Final Draft Proposed Changes to the 2020 Building Code of New York State
Issued July 2024

This document is being developed for the purpose of posting a notice of rule in development for the New York State Fire Prevention and Building Code Council (Code Council) and the New York State Department of State. The purpose is to show the final draft proposed changes to the current version of the 2020 Building Code of New York State (2020 BCNYS). Separate documents will exist for each of the current NYS specific code books. This document **is not intended to include** all of the proposed code language; it only contains those sections of code that are proposed to be new or modified. Please note that unaltered portions of the 2020 code books are not included within this document and should be considered to remain the same for this code update.

FIGURE 722.5.1(5)

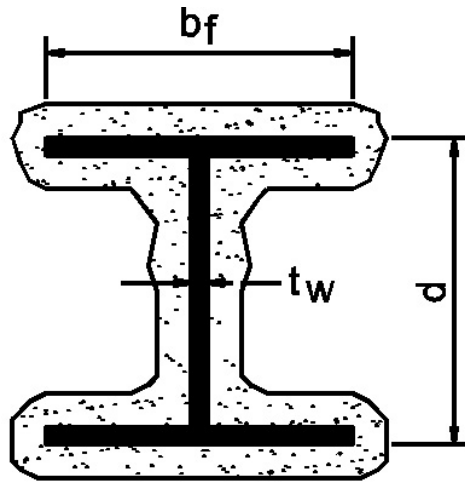
WIDE FLANGE STRUCTURAL STEEL COLUMNS WITH SPRAYED FIRE-~~RESISTIVE~~ ~~RESISTANT~~ MATERIALS

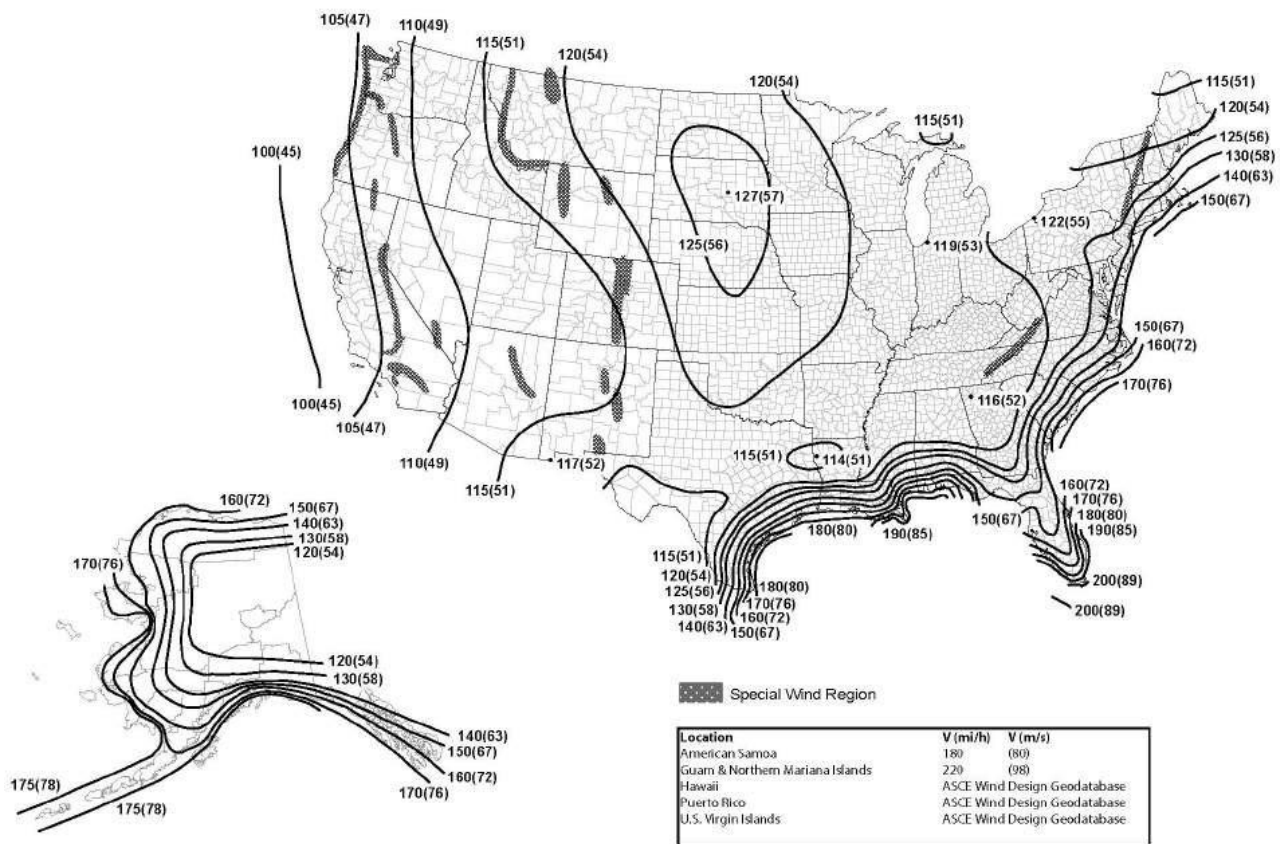
FIGURE 1609.3(4) BASIC DESIGN WIND SPEEDS, V , FOR RISK CATEGORY IV BUILDINGS AND OTHER STRUCTURES
1609.3.1 Wind speed conversion. Where required, the basic design wind speeds of Figures 1609.3(1) through 1609.3(12) (4) shall be converted to allowable stress design wind speeds, V_{asd} , using Table 1609.3.1 or Equation 16-17.

[NY] FIGURE 1613.2.1(2)

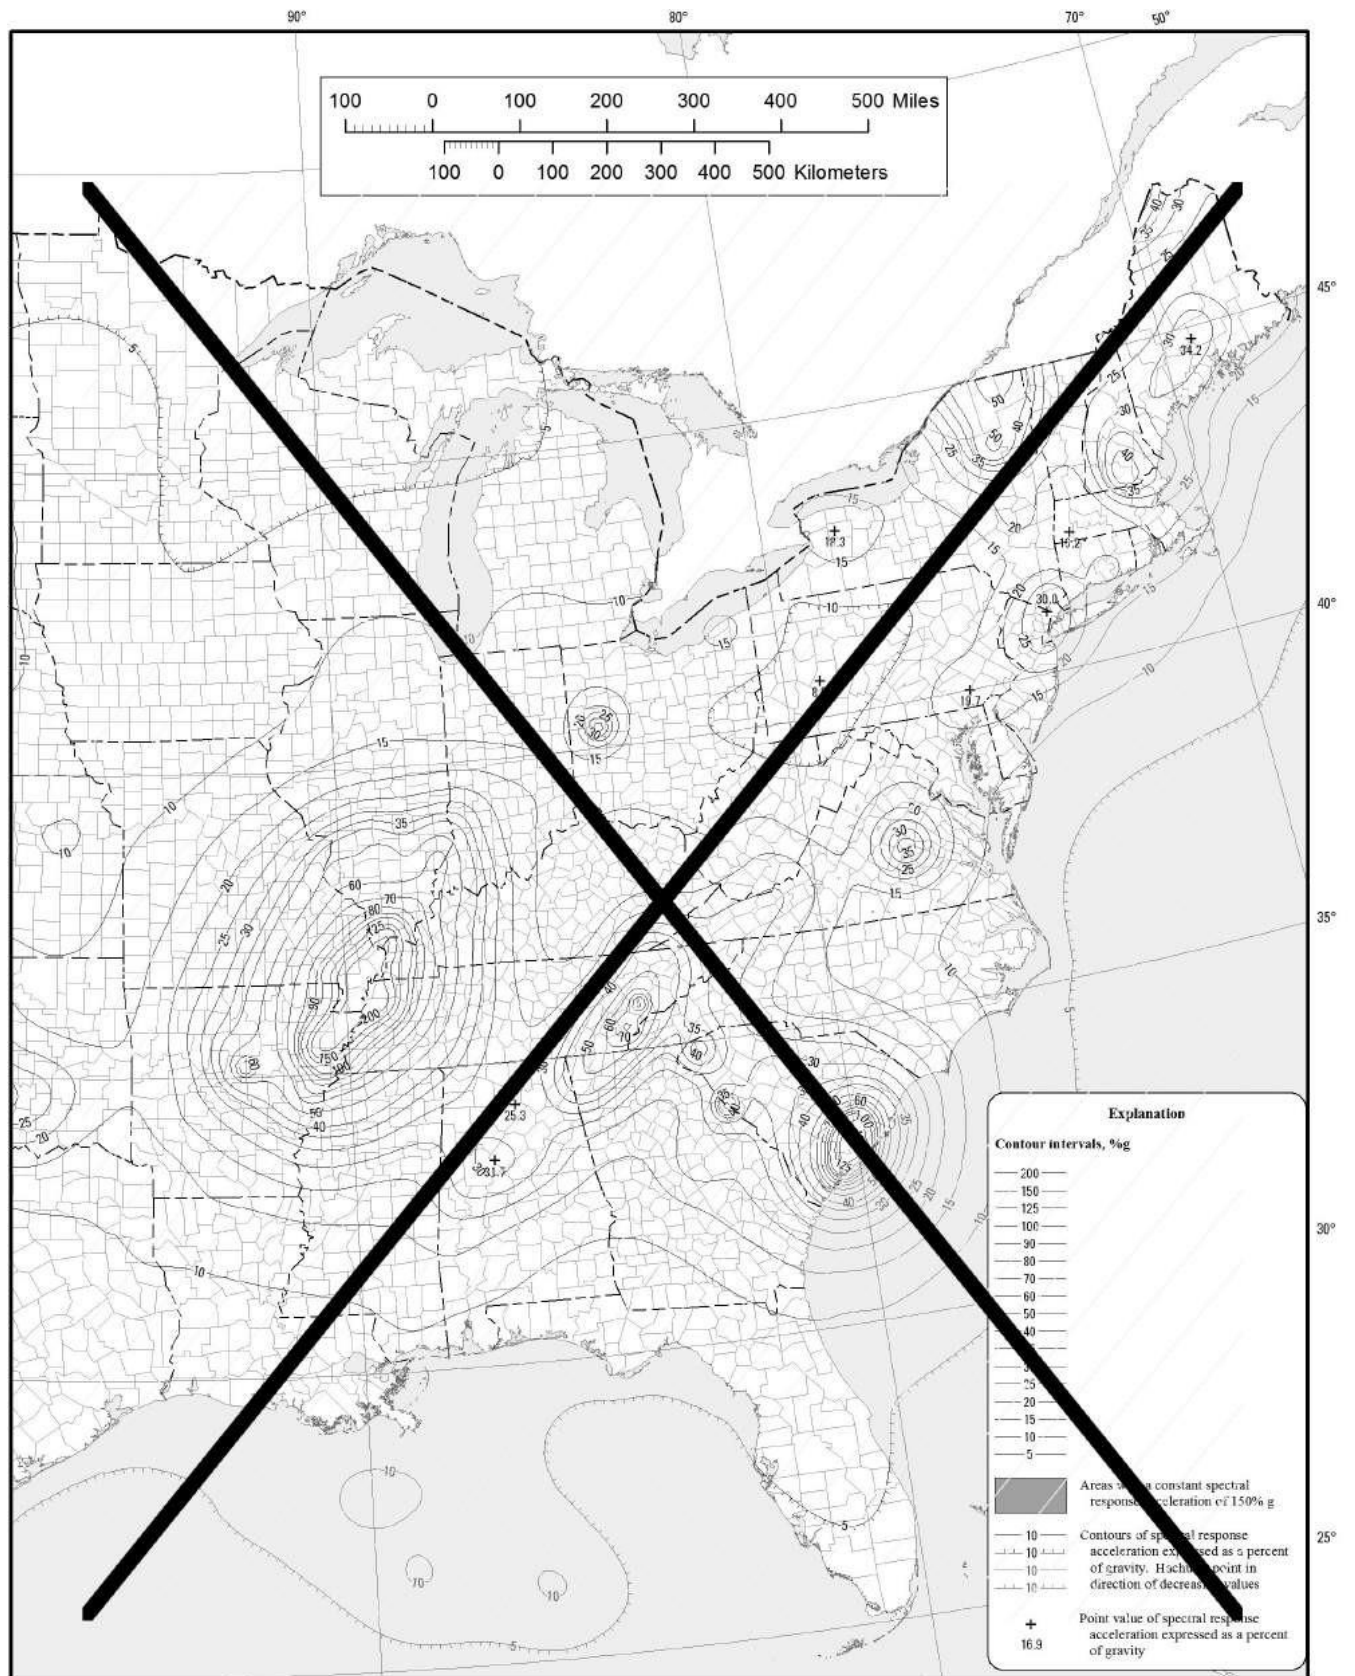
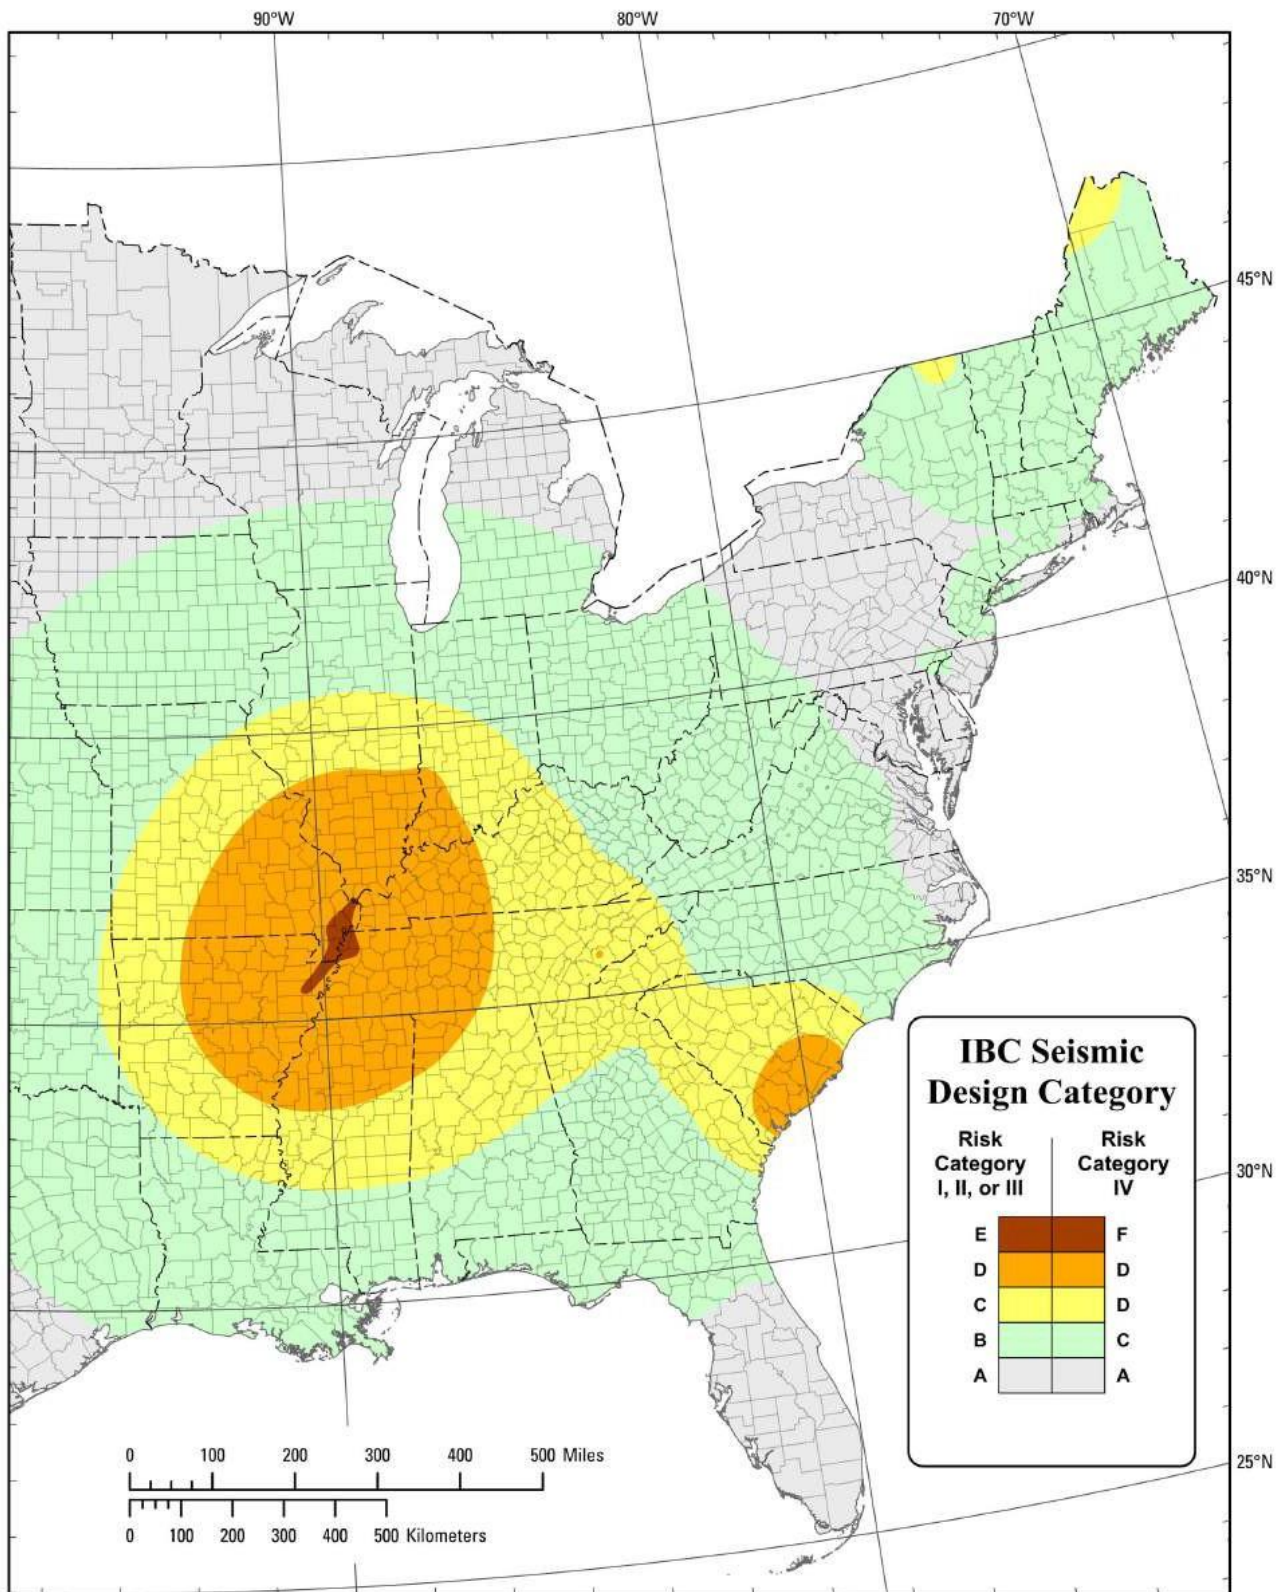
~~1613.2.1 Mapped acceleration parameters.~~

~~The parameters S_s and S_1 shall be determined from the 0.2 and 1-second spectral response accelerations shown on Figures 1613.2.1(1) through 1613.2.1(10). Where S_1 is less than or equal to 0.04 and S_s is less than or equal to 0.15, the structure is permitted to be assigned Seismic Design Category A.~~

1. Using Figure 1613.2 based on the structure *Risk Category*, or
2. Determined in accordance with ASCE 7.

FIGURE 2303.4.1.2(3)

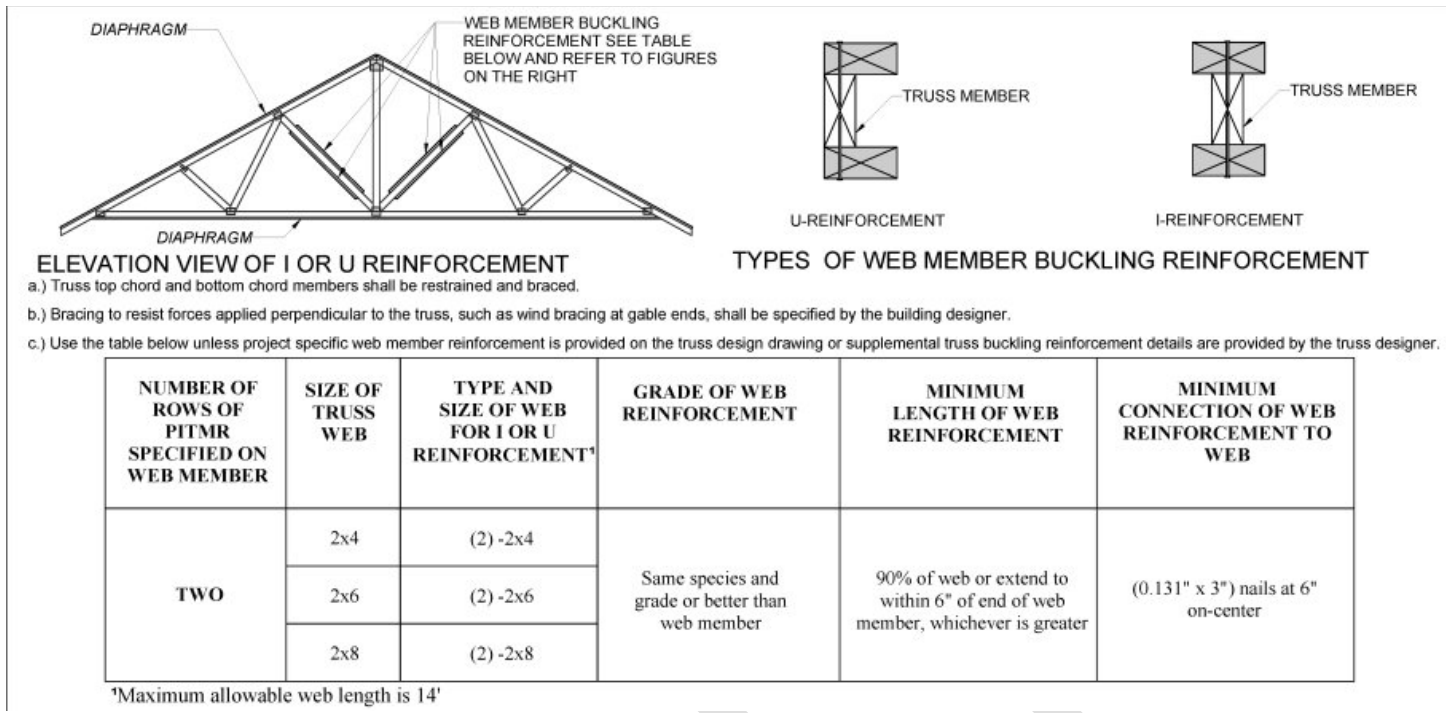
1. ~~Permanent individual truss member restraint/bracing shall be~~ PITMR and PITMDB installed using standard industry lateral restraint and diagonal bracing details in accordance with ~~generally~~ TPI 1, Section 2.3.3.1.1, accepted engineering practice, or Figures 2303.4.1.2(1), (3) and (5). ~~Locations for lateral restraint shall be identified on the truss design drawing.~~
